Addendum 3

Webster High School – Band Room & Greenhouse Additions w/ Site Improvements

10/6/2022

TO: ALL OFFICIAL PLAN HOLDERS

SHEET TITLE:
BAND ROOM ADDITION - EXTERIOR RAMP ELEVATION
INTERIOR RAMP FRAMING PLAN AND DETAILS - BLDG"C"

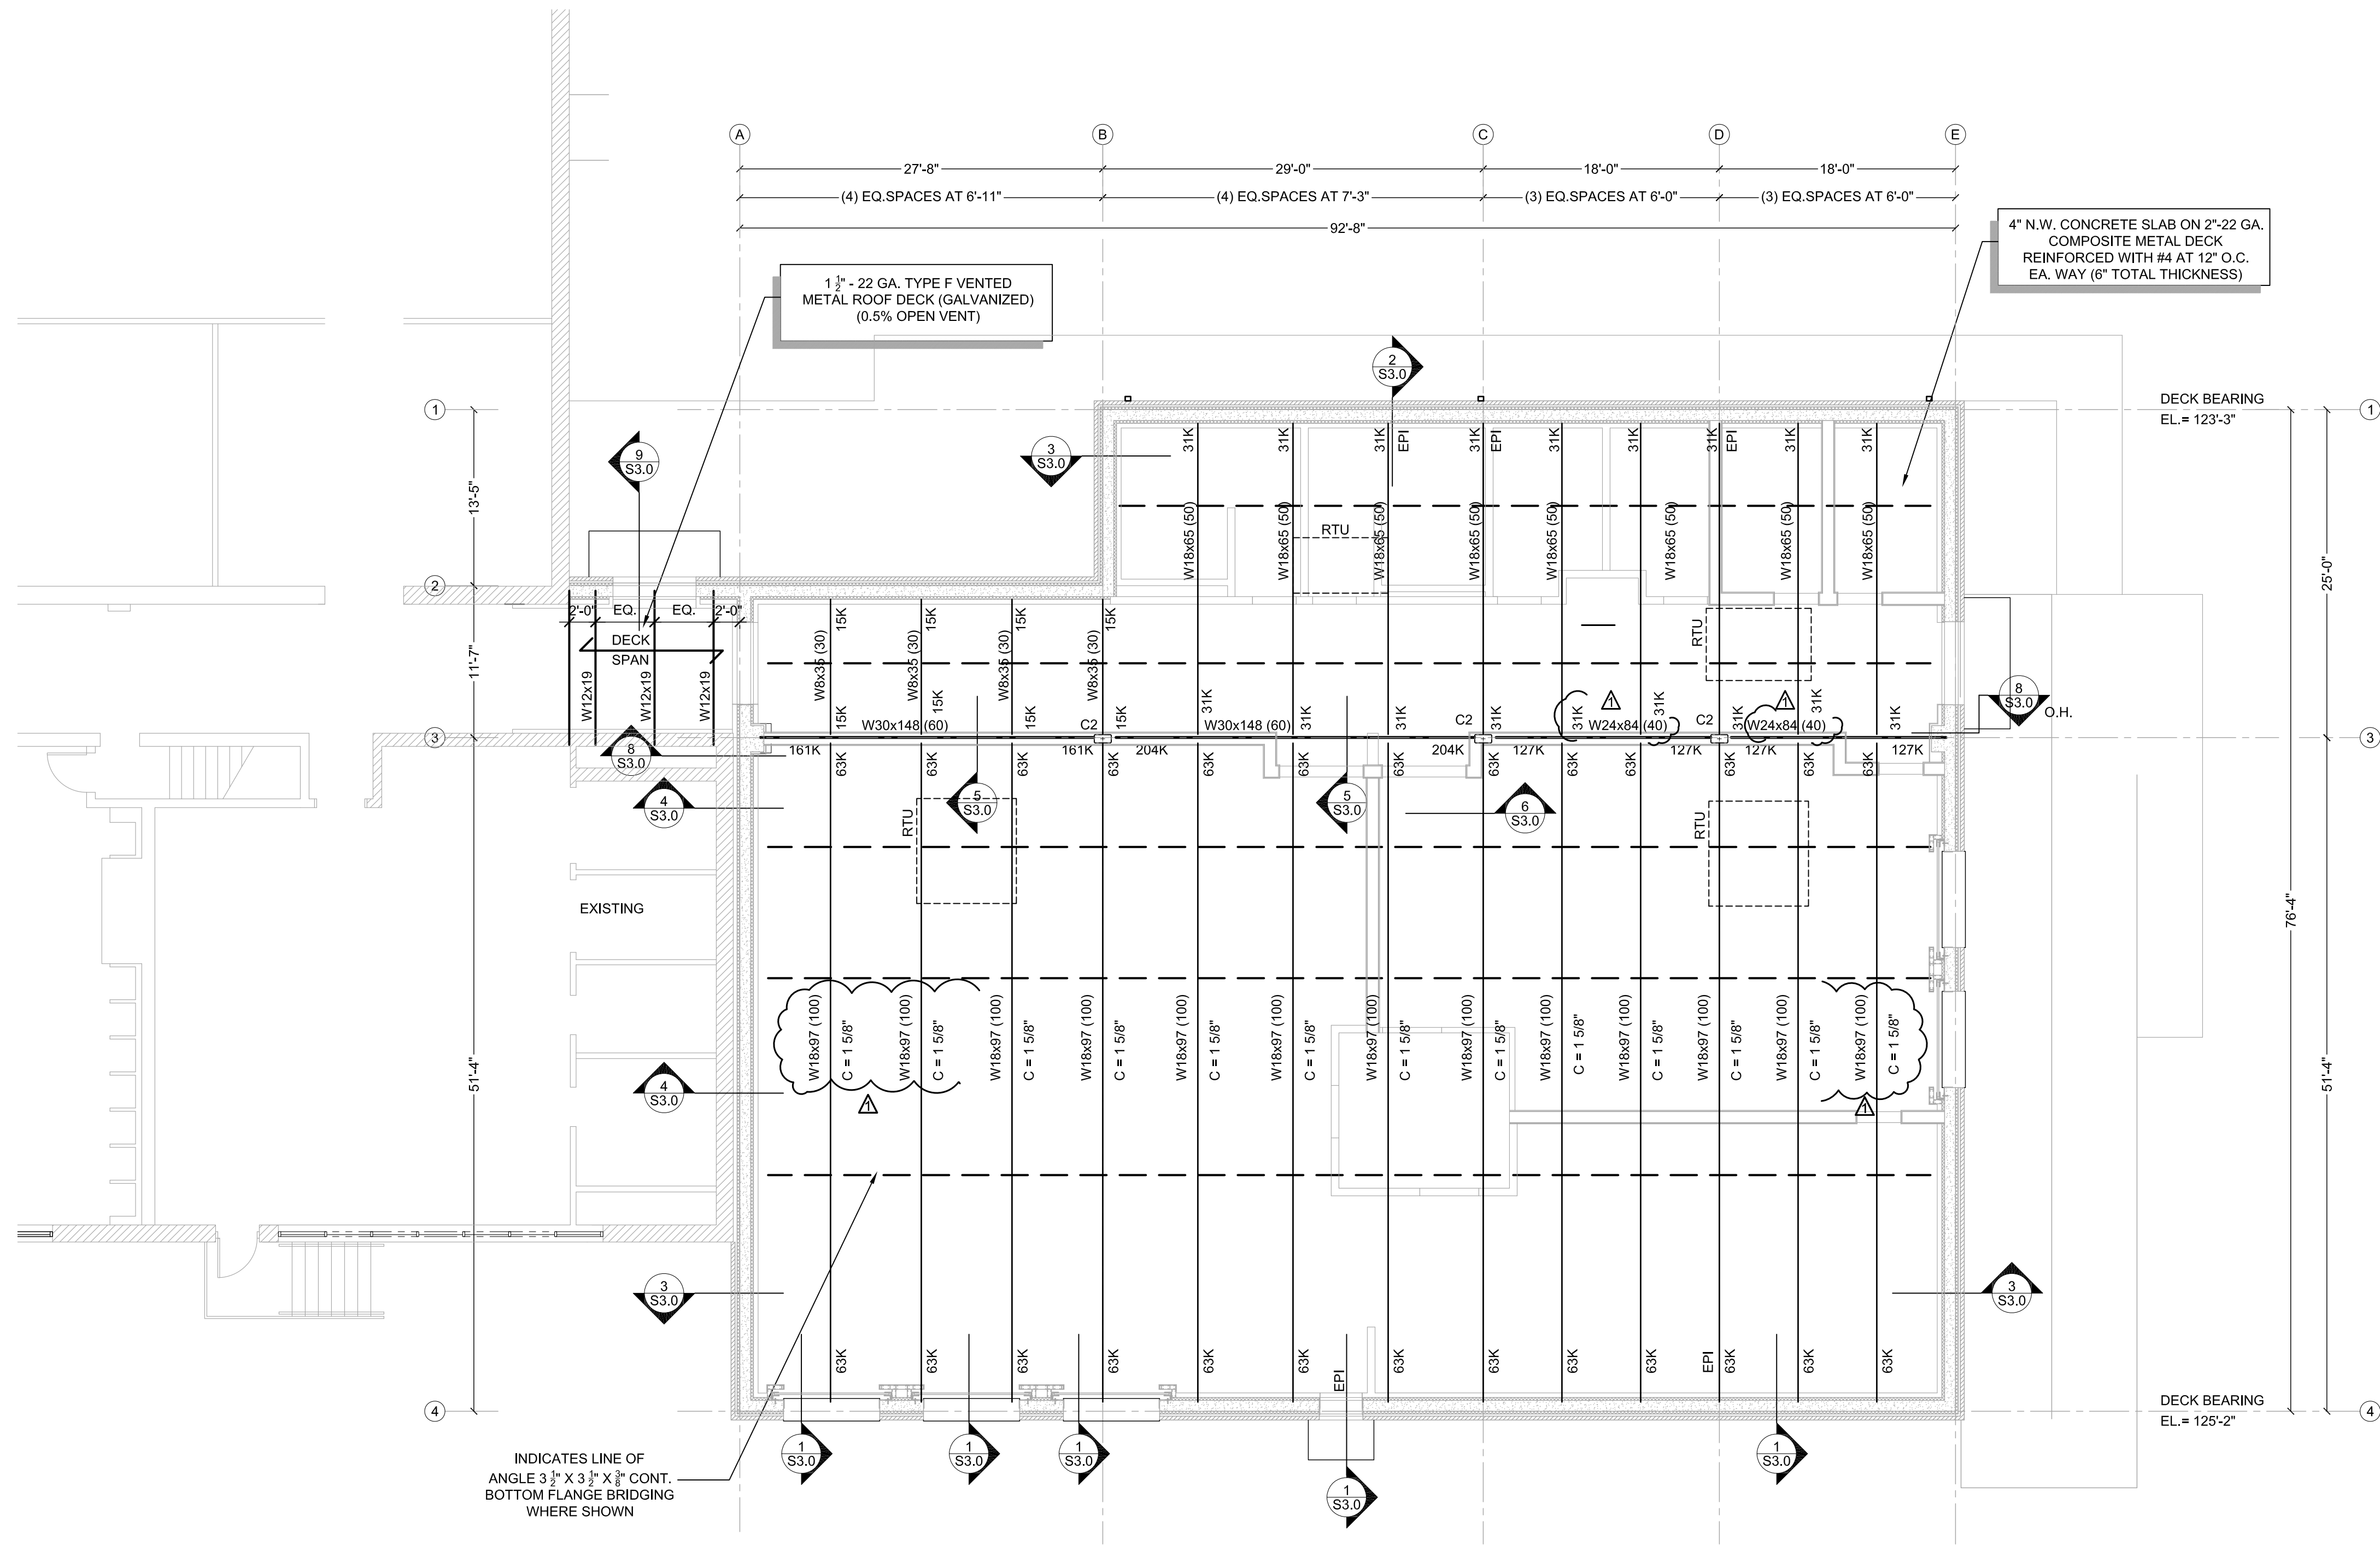
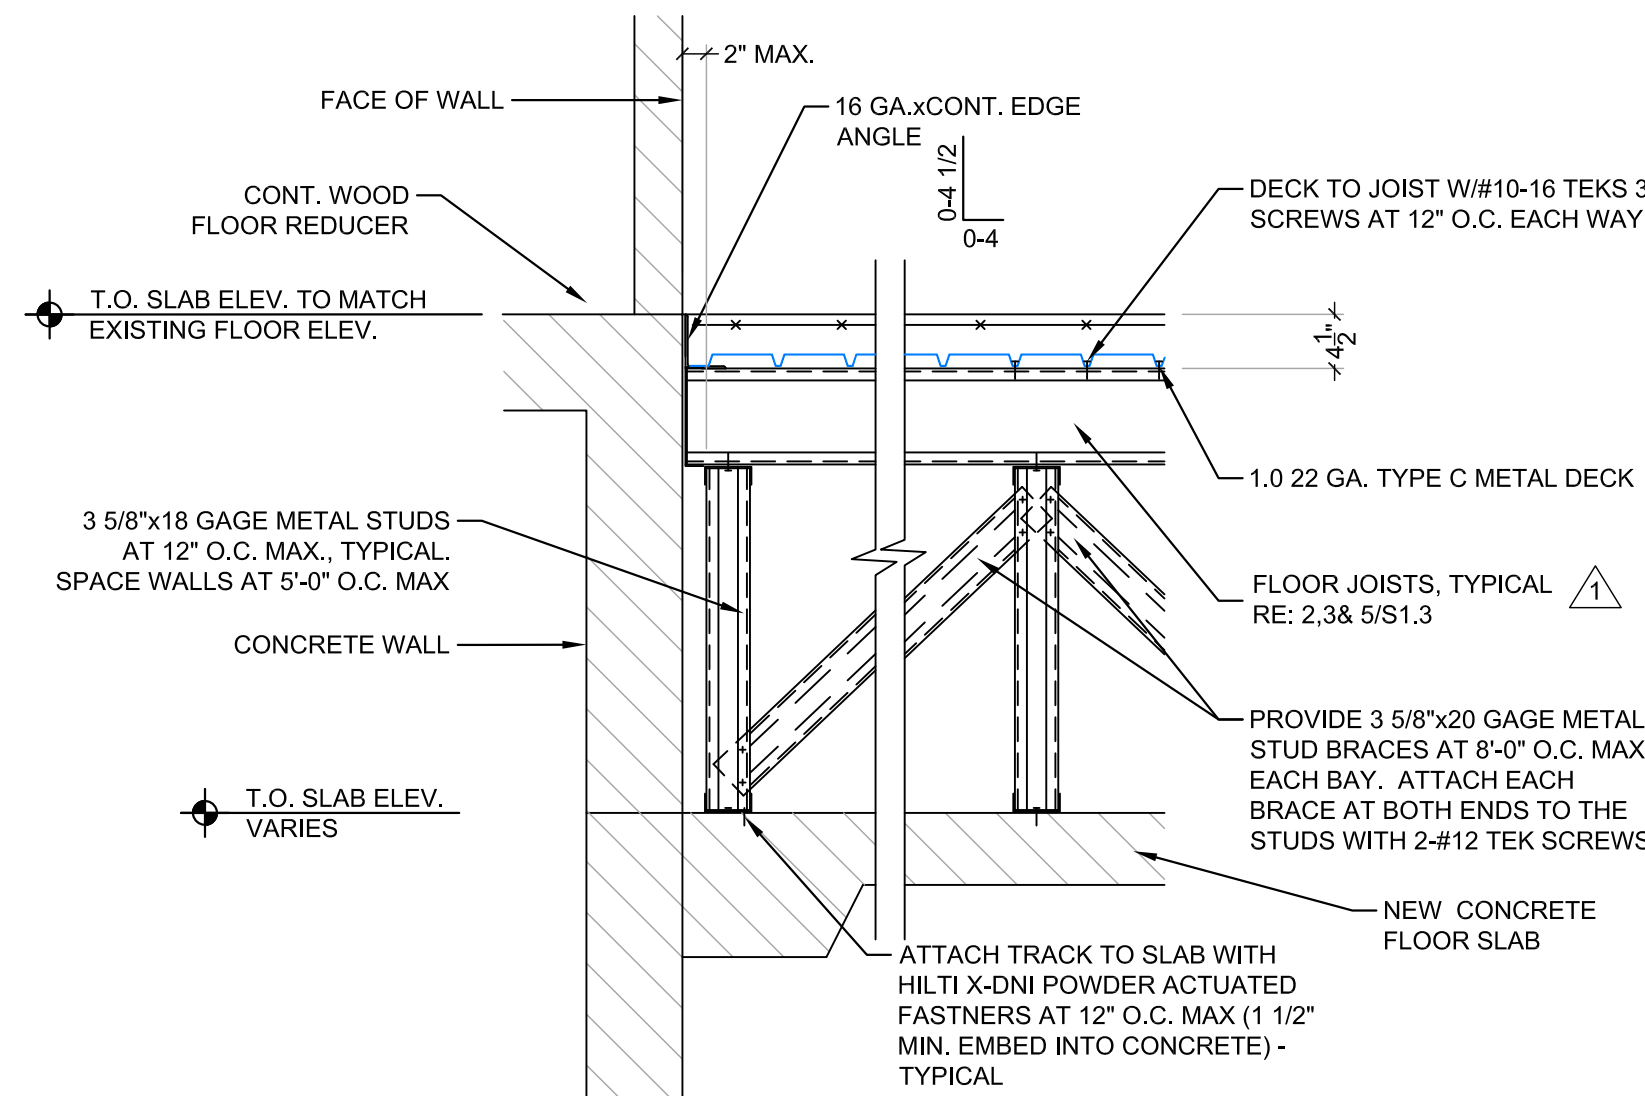
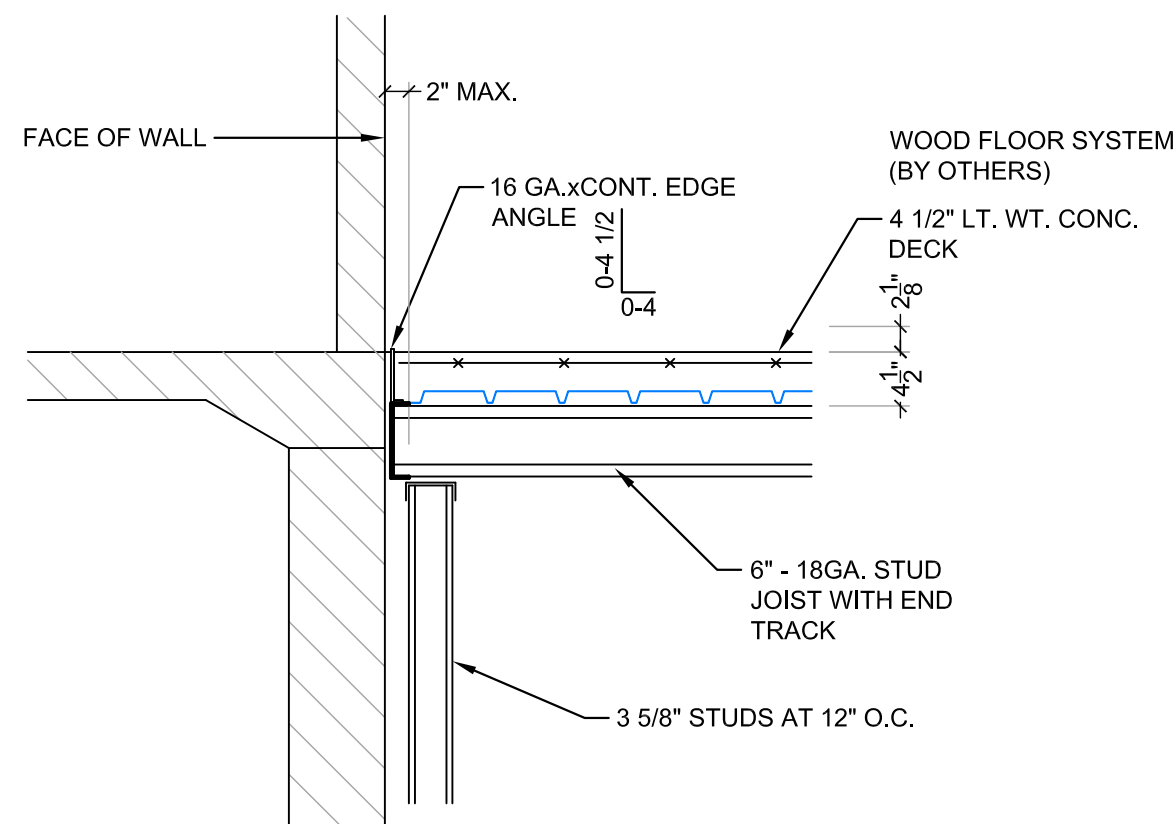
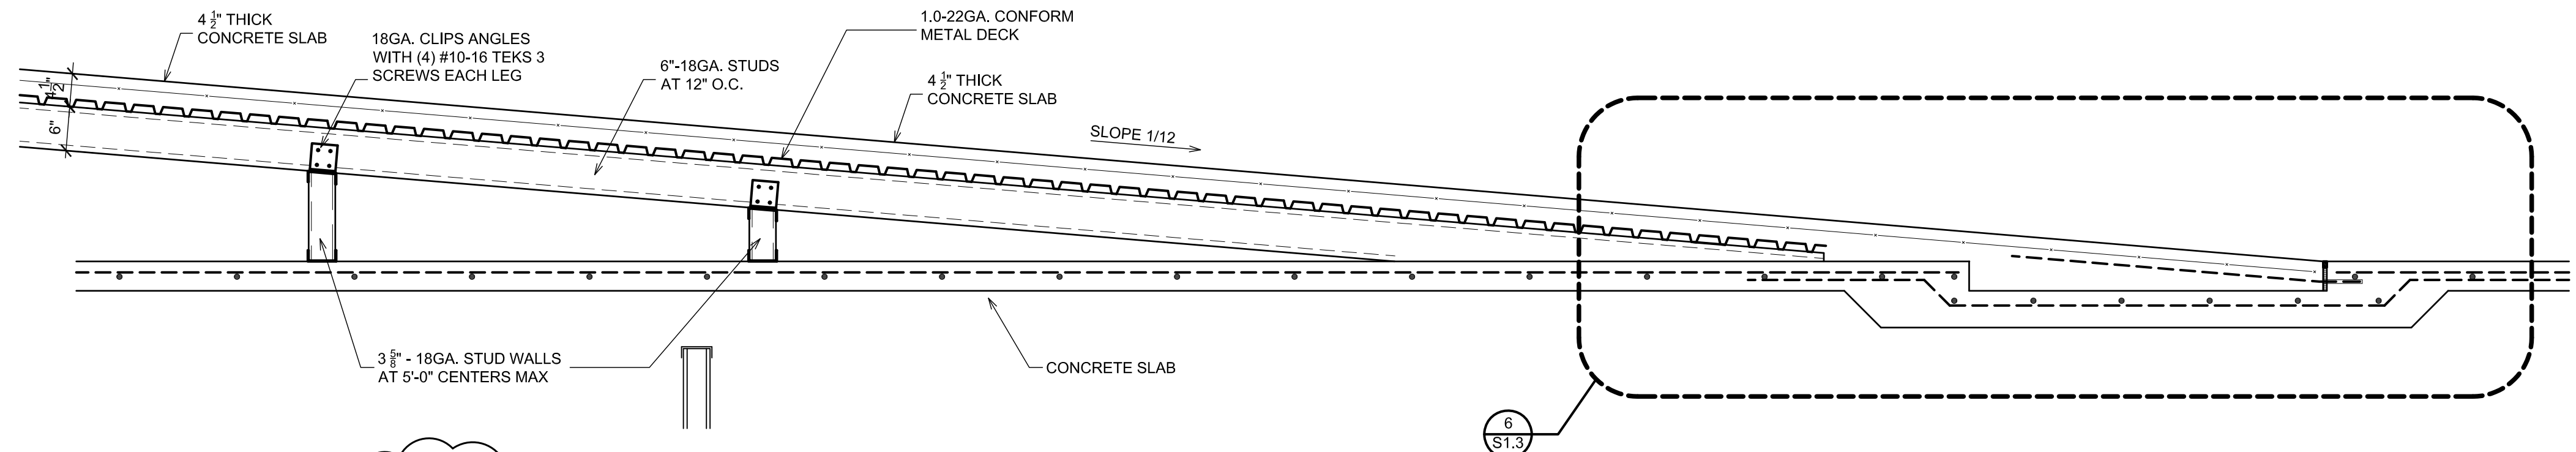
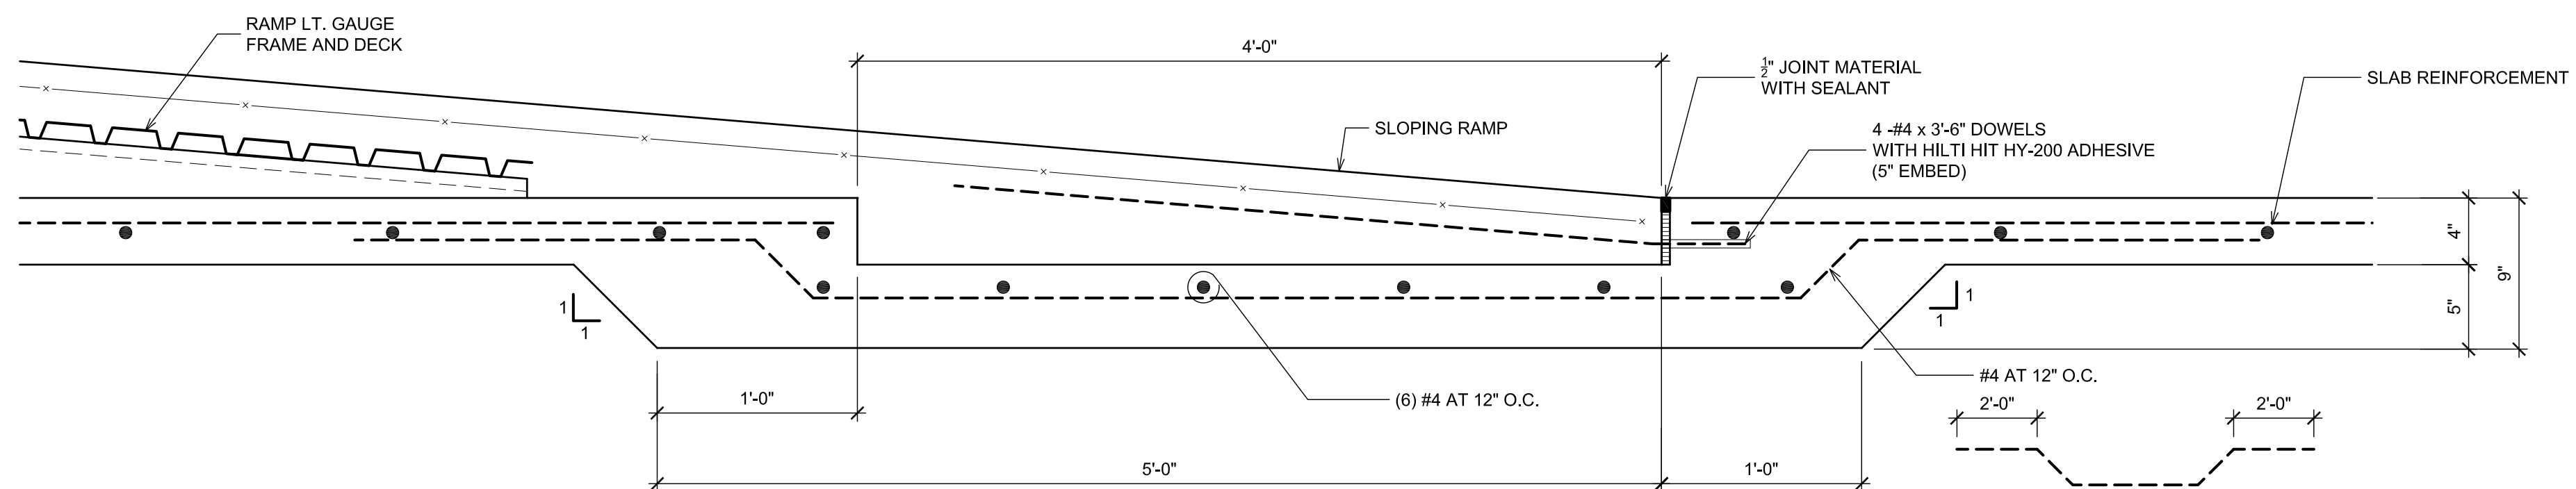
Item No. CM 1.26 **09.2 Flooring:** Include continuous wood floor reducer on sheet S1.3 detail 3.

- D. Sheet S1.2 – Details, Band Room Addition – Building “C”; revised sheet attached.
- E. Sheet S1.3 – Interior Ramp Framing Plan & Details; revised sheet attached.
